Re: 119 Barton Street, Monterey – Development Application (DA-2021/95) for a residential aged care facility

The letter has been prepared by Mecone on behalf of the SummitCare (the applicant). The purpose of this letter is to respond to the matters raised by Bayside Council (Council) in their Request for Information letter dated 22 October 2021.

Response to Council RFI dated 22 October 2021

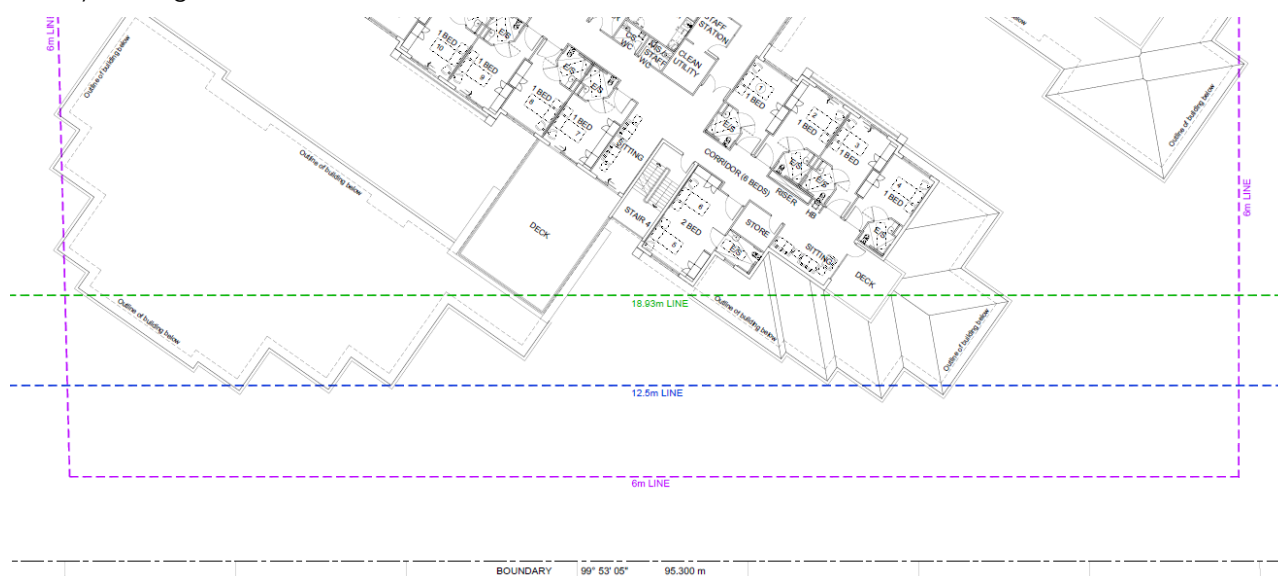
2. Clause 40(4)(c) – The **height of the building within the rear 25% of the site** is not limited to 1 storey and should be amended to comply. The clause 4.6 variation to this control as submitted is not supported. The alignment of the rear 25% shall be a straight line and not an area-based calculation. While the argument based on an area shaped control is not accepted, the development shall comply around the periphery of the battle axe lot. However, a variation may be considered given the existing building on the site.

The building design has previously been amended to include a significant increase to the second storey rear setback. This comprised an increase of 8.2m (from 4.3m to 12.5m). The variation is supported by an updated Clause 4.6 Variation Request.

The **rear 25% of the site area commences at the 18.93m green line** shown in the figure below. The first floor (red dashed line) protrudes past the 18.93m line in some areas, this however is not for the full expanse of the rear boundary. The **first floor protrudes a maximum of 6.43m beyond the rear 25% area line**, with a **minimum first floor setback of 12.5m**.

From a strict numerical standpoint, the proposal results in a **variation of 34%** (at its closest point). Further, the elements of the first floor which encroach into the rear 25% of the site comprise minor expanses of the building, due largely to the angled building envelope.
